CABINET FOR HEALTH AND FAMILY SERVICES  
 DEPARTMENT FOR PUBLIC HEALTH  
 ONSITE SEWAGE DISPOSAL SYSTEMS  
 SITE EVALUATION

1-347-17  
 Application No.

Owner's Name Danny Raiser

Lot Address Lot 35 Valley View Estates

✓ SITE PLAN  
— PROPOSED SYSTEM  
— INSTALLED SYSTEM

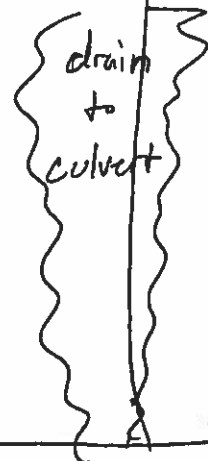
Met Danny Raiser + Jackie Fyke (installer) w/ backhoe.  
\* Majority of lot is shallow to massive clay.  
\* Will require partial if not all fill + wait option.  
~~\* Not approved at this time.~~

⊕ massive 2"

⊕ massive @ 0"

⊕ 42"  
Small plateau

⊕ massive 10"
